FINAL PLAT
KISER WEST ADDITION
AN ADDITION TO WICHITA SEDGWICK COUNTY, KANSAS

RE: SUB 2001-74 -- One-Step Final Plat of Kiser West Addition

RE: SUB 2001-74 -- One-Step Final Plat of Kiser West Addition

CASE NUMBER: SUB 2001-74 -- KISER WEST ADDITION

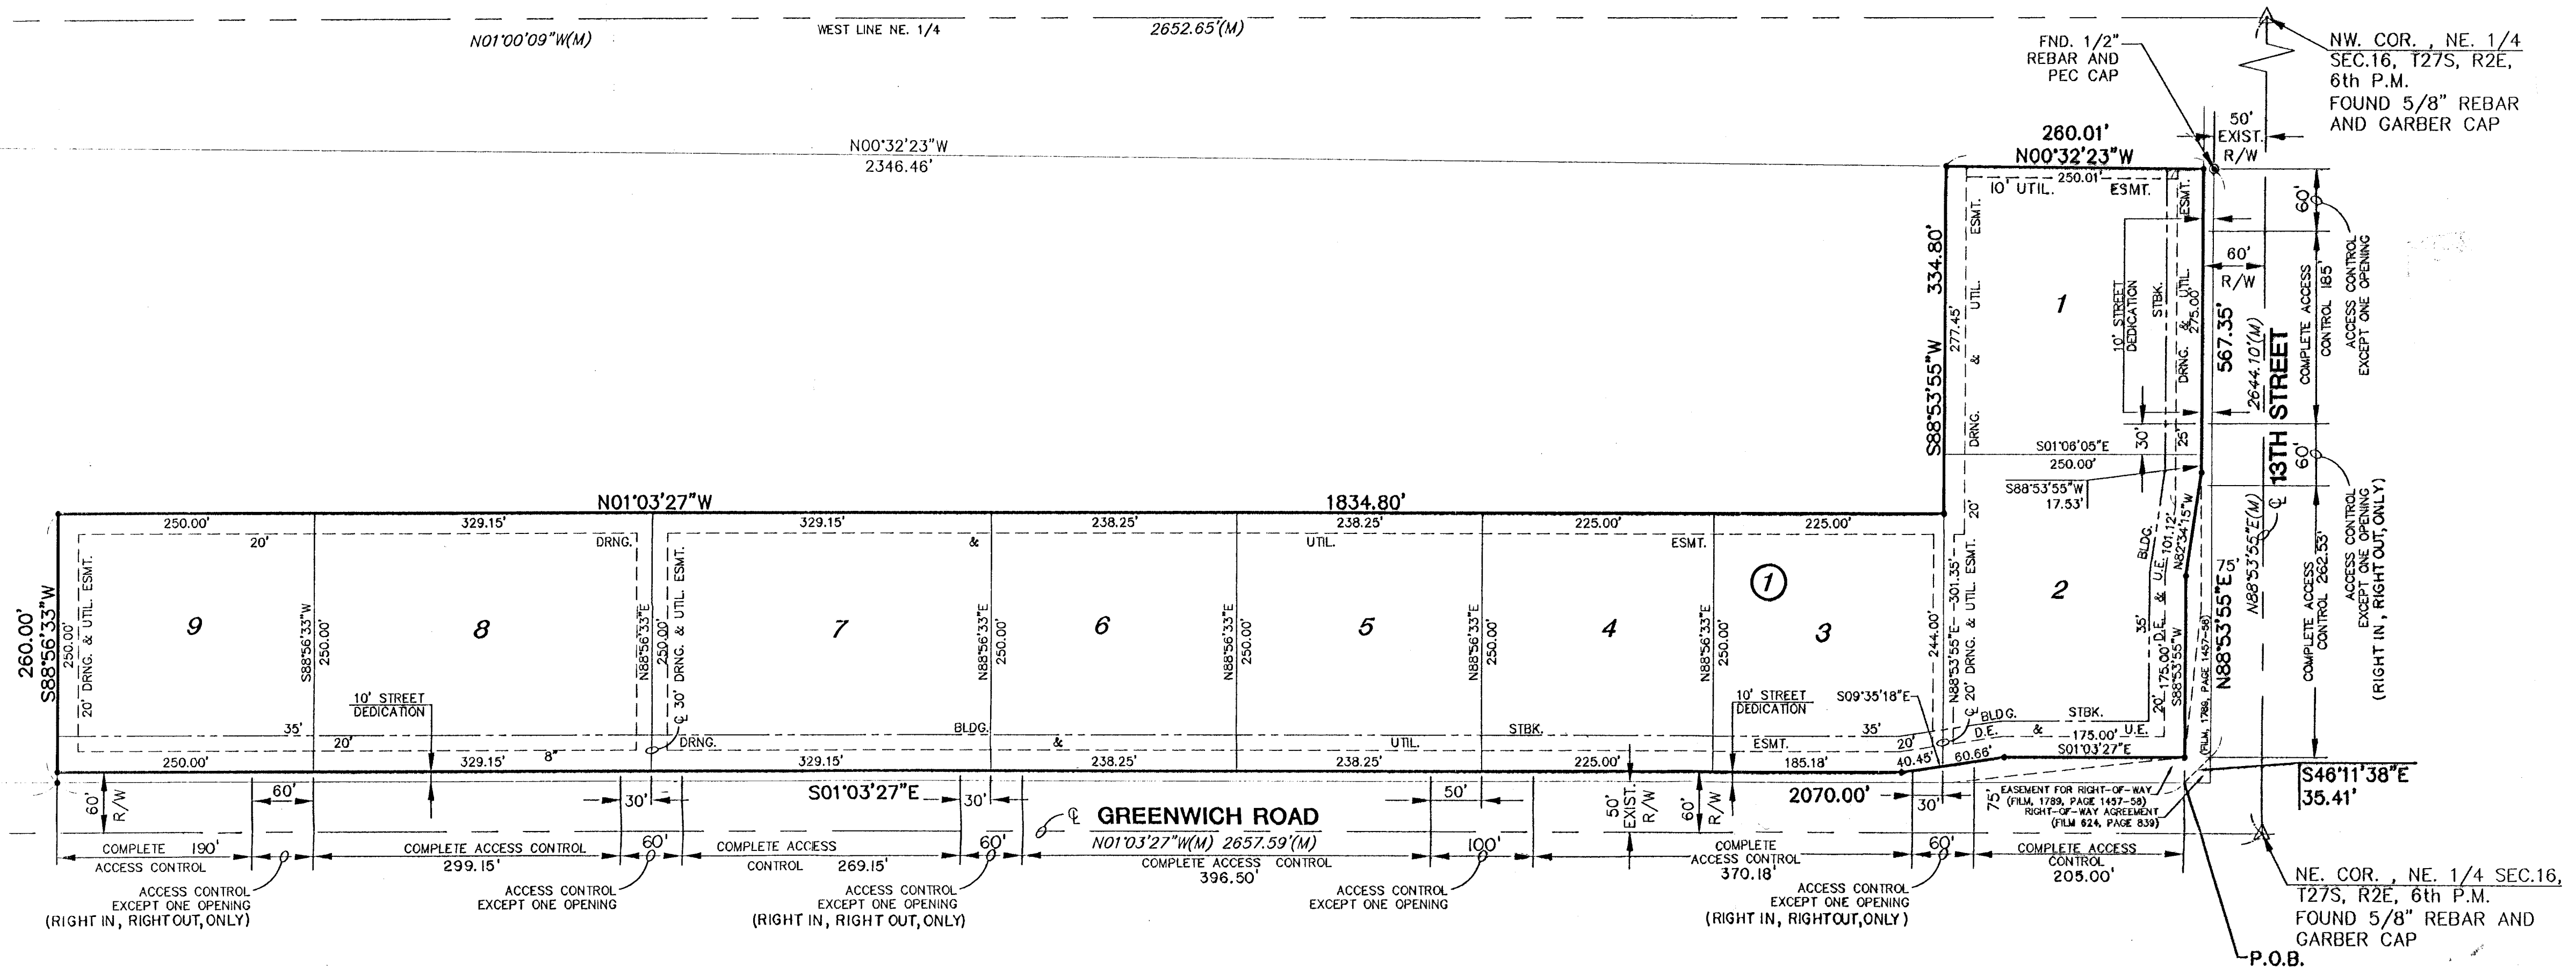
- E. The plat proposes five access openings along Greenwich and two access openings along 13th St. Distances should be shown for all segments of access control. In accordance with the CUP approval, the access openings located between lots 1 and 2, 2 and 3, and between lots 6 and 7 are limited to right-turns only, and shall be referenced on the face of the plat.

- J. On the final plat, the MAPC signature block needs to reference "J.D. Michaelis, Acting Chair".
- K. The applicant needs to revise the legal description to accurately portray the land being platted. If the platted description is different than the legal, then both descriptions shall be shown.

- L. On the north line of Lot 2, the extra "35 feet" label may be removed.
- M. The spelling of the label at the center of the section should be corrected to "Center".

- N. A dimension needs to be added on the south line of the 25-ft drainage and utility easement on the north side of Lot 1.
- O. The labeling of dimensions and dedications along 13th Street and within Lots 1 and 2 needs to be reoriented 180 degrees to be aligned with the north arrow.
